WORKING DRAFT OF NEC CODE-MAKING **PANEL 12 MEETING OUTPUT**

Document: National Electrical Code®

Revision Cycle: A2025

Meeting Dates: January 21 - 23, 2024

Informational Note Figure 620.62 Selective Coordination for overcurrent protective devices supplying more than one elevator.

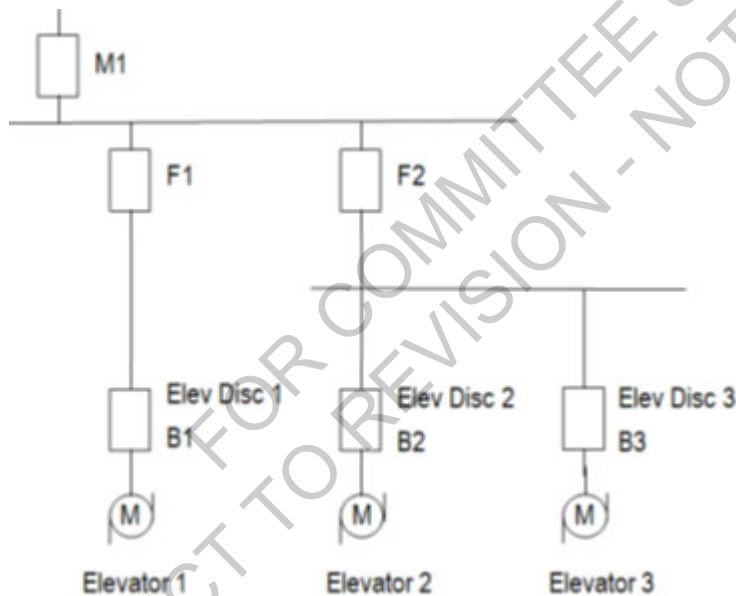
Where elevator system(s) OCPDs are replaced, they shall be reevaluated to ensure selective coordination is maintained with all supply-side and load-side OCPDs.

If modifications, additions, or deletions to the elevator system(s) occur, selective coordination of the elevator system(s) OCPDs with all supply-side and load-side OCPDs shall be reevaluated.

Informational Note: See Figure Informational Note Figure 620.62 for an example of how OCPDs supplying elevators selectively coordinate with all supply-side OCPDs.

Committee Statement: This revision is necessary to provide clarification that if any component in the system is replaced, the selective coordination needs to be reevaluated. Exception and informational note were added to provide clarity to the requirement for how the devices selectively coordinate with each other.
